Connection Network Codes – Response to the comments received during the public consultation of Implementation Guidance Documents on Frequency Stability Parameters

Period of Consultation: 20/11/17 - 21/12/17

31 January 2018

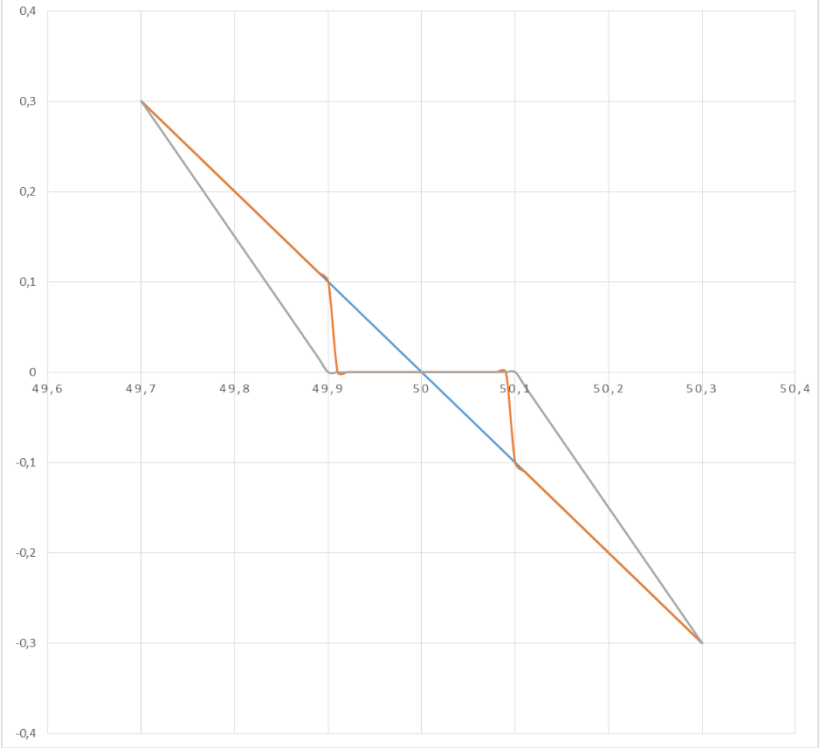
Technical	5/ Figure 1 page 7: This figure is not clear for me... are we showing here a result of a deadband or a result of an insensitivity?		Accepted. Title to be changed to : "Frequency profile observed with insensitivity modelled as an Active Dead-band (red curve)"
Technical	6/ deadband: asymmetrical deadband should be possible (one must consider that some generation facilities are more suitable to provide either positive reserve only either negative, or both.		Rejected. Regarding the capability the deadband should be symmetrical.
